Docket No. RM16-1-000

**COMMENTS OF THE
NORTH AMERICAN ELECTRIC RELIABILITY CORPORATION
IN RESPONSE TO NOTICE OF PROPOSED RULEMAKING**

Proposal to Revise Standard Generator Interconnection Agreements

Figure 2: Proposed Non-Synchronous Generation Reactive Power Capability Curve

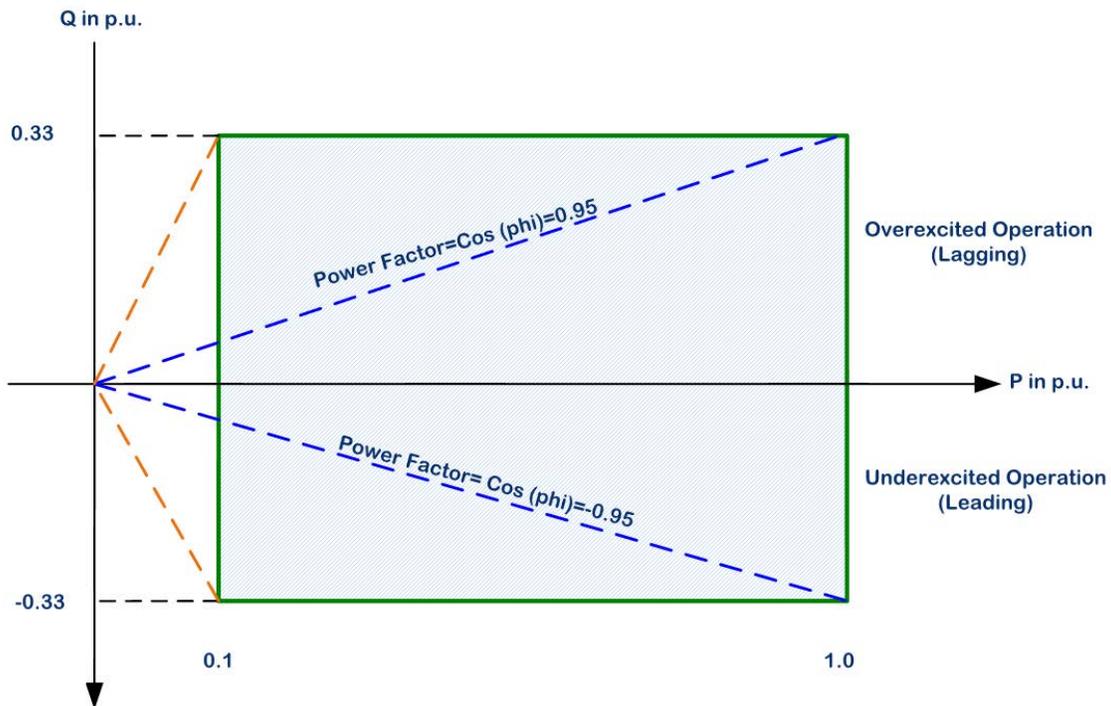
Figure 2 depicts the reactive capability for the required power factor range of 0.95 leading to 0.95 lagging. The non-synchronous generating facility must be able to provide reactive capability over full range of real power output down to 10% of rated power. The reactive capability bounds are determined by calculating the reactive power output for a ± 0.95 power factor, as shown by the green box in Figure 2. The blue lines in Figure 2 specify the reactive power production or consumption if operated in a constant power factor

mode. NERC interprets the FERC NOPR to require this type of reactive capability, and agrees with this approach assuming that POI voltage is addressed as described below.

Figure 4: Reactive Capability Corresponding to POI Voltage [Source: CAISO⁷]

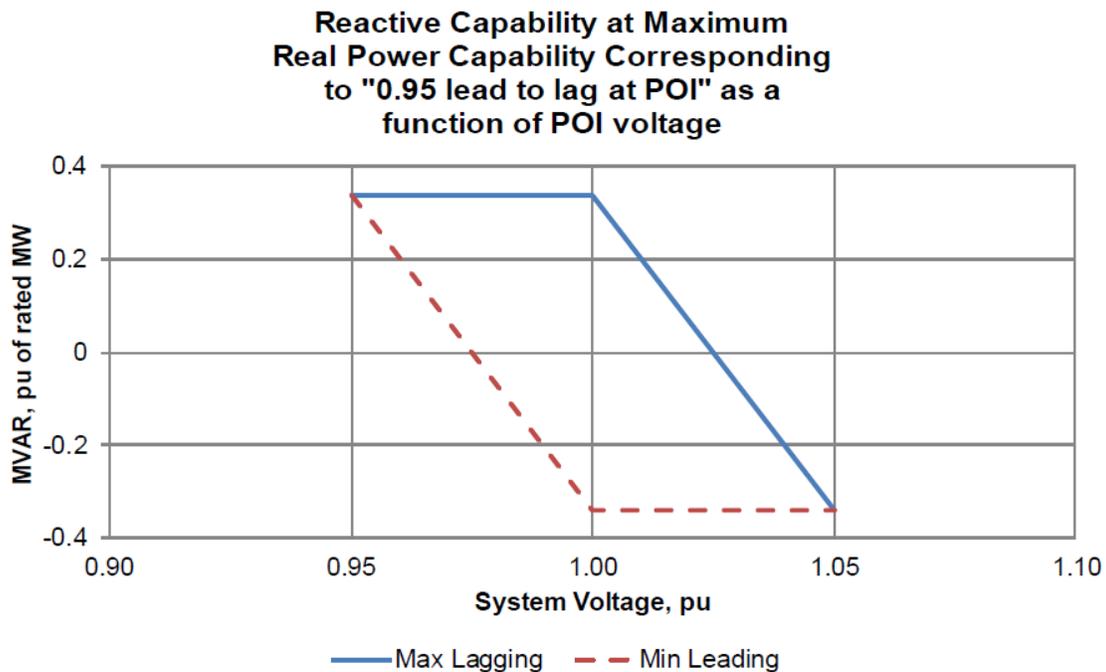
The specification of 0.95 leading to 0.95 lagging power factor at full active power output proposed by FERC is slightly ambiguous because it does not address Point of Interconnection (POI) voltage. Terminal voltage limitations of the units can affect reactive power capability and therefore a reactive power versus voltage characteristic should be used in conjunction with the capability specification. Figure 4 shows an example of this Q vs. V capability curve. The non-synchronous power plant must have the capability to provide reactive power at 0.95 lagging when voltage is between 0.95 - 1.0 pu at the POI. Similarly, the non-synchronous power plant must have the capability to absorb reactive power at 0.95 leading when voltage is between 1.0 - 1.05 pu. Capability to provide reactive power decreases as voltage at the POI exceeds 1 pu; capability to absorb reactive power decreases as voltage at the POI drops below 1 pu. This is used as an illustration and may need to be adapted by Transmission Providers dependent on voltage schedule needs (e.g., based on POI voltage level).

NERC Position: NERC agrees with the requirement for non-synchronous generation to comply with providing a “composite power delivery at continuous rated power output at the Point of Interconnection at a power factor within the range of 0.95 leading to 0.95 lagging, unless the Transmission Provider has established different requirements that apply to all similarly situated generators in the control area on a comparable basis.” Review of inverter-based non-synchronous generation has identified that modern Wind Turbine Generator (WTG) technology can provide the full range of required power factor capability when online. For situations where the WTG itself cannot meet the full power factor requirements, dynamic reactive devices such as STATCOMs or SVCs can be employed to expand reactive capability. However, it is unclear what the power factor requirement refers to explicitly with respect to power factor capability at active power outputs other than nominal. It is assumed that the non-synchronous generation must meet the 0.95 leading to 0.95 lagging power factor capability using continuously-acting dynamic reactive resources for all real power outputs above 10% of nominal. This assumes a “box”-type reactive capability range. FERC should clarify this using a reactive capability diagram for non-synchronous generation plants, as measured at the Point of Interconnection (POI). In addition to the reactive capability curve, a complete specification should address the expected capabilities during off-nominal voltages. Non-synchronous generation may not, and should not necessarily, be required to provide full capability range at all operating voltages (e.g., a generator should not be required to provide full reactive power consumption when low voltage conditions are occurring at the POI). A reactive capability versus voltage characteristic would clearly address this issue and is recommended.

Figure 5: Proposed Non-Synchronous Generation Reactive Power Capability Curve

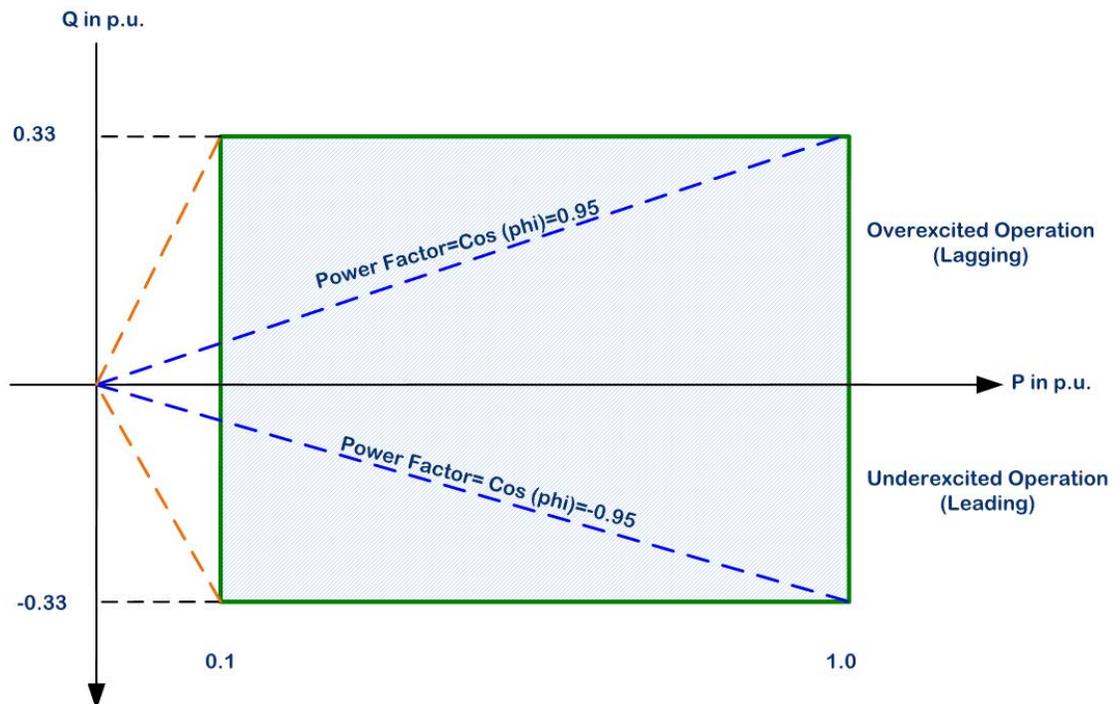
Figure 5 again depicts the reactive capability for the required power factor range of 0.95 leading to 0.95 lagging. The non-synchronous generating facility must be able to provide reactive capability over full range of real power output down to 10% of rated power.

The preceding section gives examples of actual WTGs and their capabilities, and illustrates how the WTGs themselves can provide sufficient reactive power control; however, at very low output levels it is hard for the plant as a whole to control VARs because the WTGs are cycling between power production and offline. Since all or a large portion of the generators in a wind or solar plant may be offline during periods of low output, it is difficult to meet the full range of reactive capability at low real power output levels. Therefore, a permissive reactive power range (i.e., 10% of nominal real power rating) where the plant does not have to meet the reactive power capability envelope is technically justifiable and reasonable.

NERC Position: FERC’s proposed permissive reactive power range for low real power output is technically justified and reasonable. A 10% minimum active power output level accounts for a dispersed power producing resource such as wind or solar not being able to provide full capability range due to cycling individual units. At low output, some WTGs or PV inverters may be offline resulting in a reduction of reactive capability. Therefore, a 10% minimum active power output level accounts for this technology limitation while ensuring full dynamic reactive capability when attainable.

Figure 6: PRC-024 Low Voltage Ride Through Duration Curve

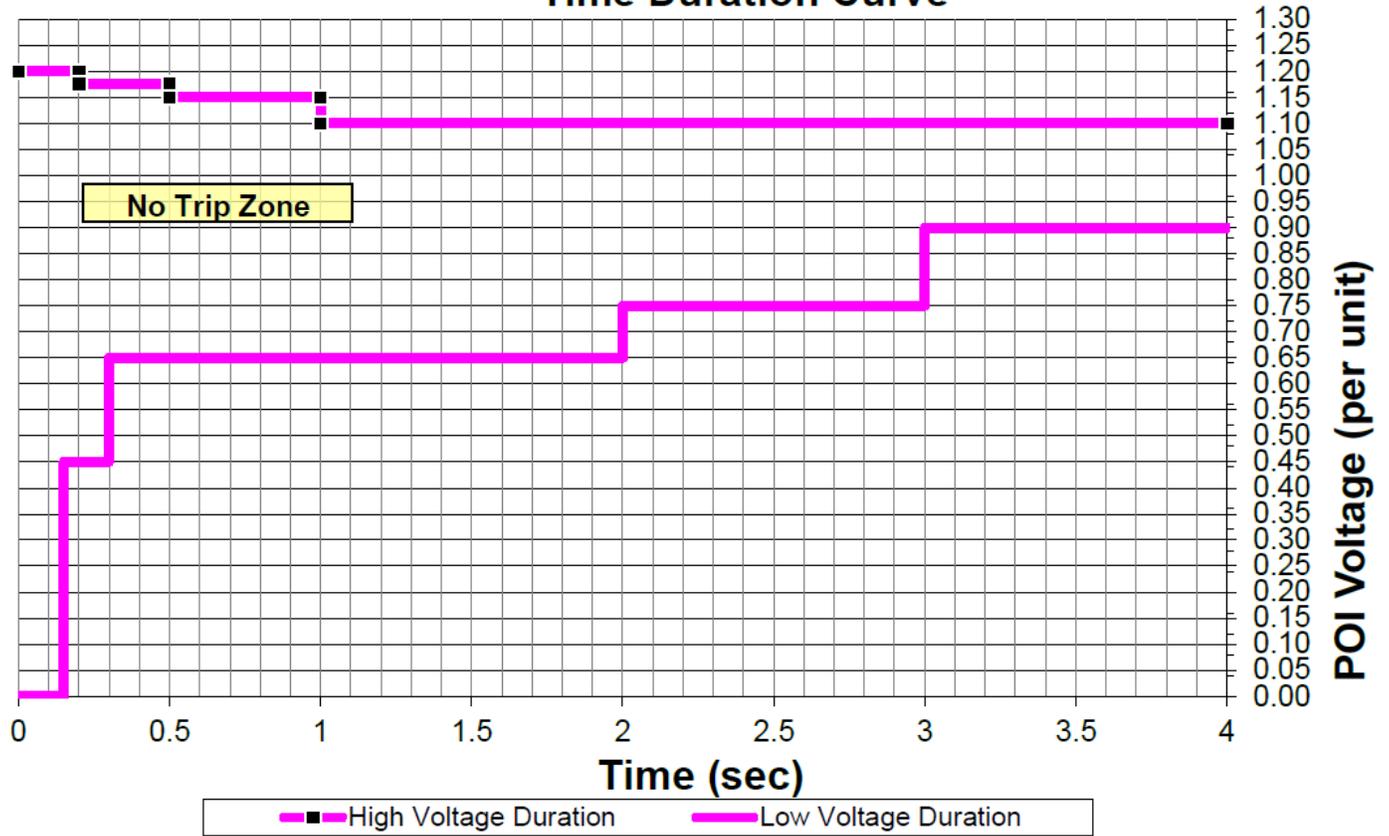
NERC Event Analysis has experienced a number of such events where the generating facility or unit was tripped due to auxiliary loads tripping, not generator protective relaying causing the disconnection. Requirements by FERC, similar to those set forth in Appendix G, for both synchronous and non-synchronous Generation Facilities regarding LVRT would ensure continuity of the BES generation.

NERC Position: Voltage ride through (VRT) is not discussed in this FERC NOPR; however, NERC sees a possible inequity with respect to Low Voltage Ride Through (LVRT) requirements for BES synchronous and non-synchronous generators. On one hand, Appendix G of the LGIA, applicable only to wind plants, specifies that the Generation Facility must not disconnect for voltages and times specified as per the Appendix. This requirement ensures that the Generation Facility remains connected for expected times, regardless of what may cause it to disconnect. On the other hand, NERC Reliability Standard PRC-024 applies to all BES generators, including wind and solar facilities that are BES Elements; however, it only prescribes that the generator voltage protective relays must be set according to the Standard and does not address auxiliary equipment that may trip the generator offline. NERC believes that FERC may want to consider a VRT requirement, similar to Appendix G, for all Generation Facilities including synchronous generators. NERC Event Analysis has experienced a number of events where the generating facility or unit was tripped due to auxiliary loads tripping, not generator protective relaying causing the disconnection.
